Access Compliance Report

Public Rights-of-Way

Intersection ID: 3525	Main Street: BRIDLE_RIDGE_LN	Cross Street: STEED_CT	Location:	S
ADA ID: CB46CE5F5857	Ramp Type: Perp	Initial Pass/Fail: Fail	Overall Compliance: No	Severity Score: 10

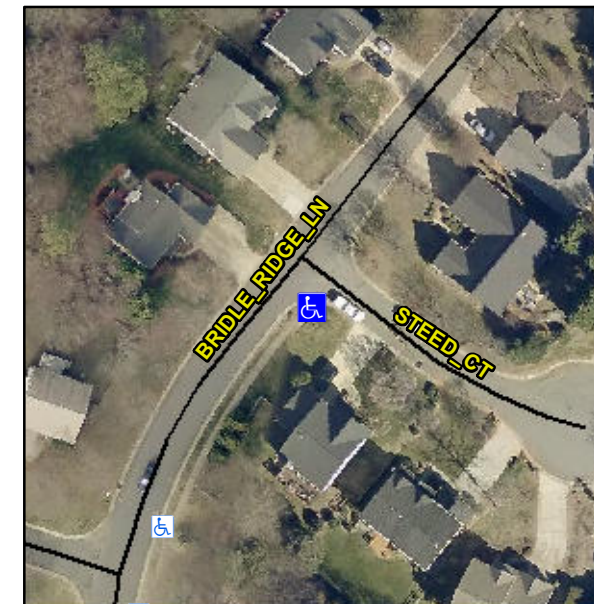
Not Found, R304.5.1, R304.5.3

Compliance	Description	Data	Compliance	Description	Data
N/A	Ramp Length (in)	49.0	Yes	Ramp Slope (%)	8.1
No	Ramp Width (in)	45.0	No	Ramp XSlope (%)	3.2
N/A	Flare Type LT	N/A	N/A	Flare Type RT	N/A
N/A	Flare Slope LT (%)	N/A	N/A	Flare Slope RT (%)	N/A
N/A	Flare Traversable LT?	N/A	N/A	Flare Traversable RT?	N/A
N/A	Landing Length (in)	N/A	N/A	DWS Provided?	N/A
N/A	Landing Width (in)	N/A	N/A	DWS Contrast?	N/A
N/A	Landing Slope (%)	N/A	N/A	DWS Length (in)	N/A
N/A	Landing X Slope (%)	N/A	N/A	DWS Full Width?	N/A
N/A	Landing Curb? (Y/N)	N/A	N/A	DWS Offset (in)	N/A
N/A	Shared Landing?	N/A			
N/A	Gutter Ponding?	N/A	N/A	Gutter Slope (%)	N/A
N/A	Gutter Lip Ht (in)	N/A	N/A	Gutter X Slope (%)	N/A
N/A	Painted X Walk1?	No	N/A	Painted X Walk2?	N/A
	X Walk 1 Direction	To NE		X Walk 2 Direction	N/A
N/A	X Walk 1 Width (in)	N/A	N/A	X Walk 2 Width (in)	N/A
	X Walk 1 Slope (%)	1.4		X Walk 2 Slope (%)	N/A
	X Walk 1 X Slope (%)	2.3		X Walk 2 X Slope (%)	N/A

Remove & Replace Entire Ramp.
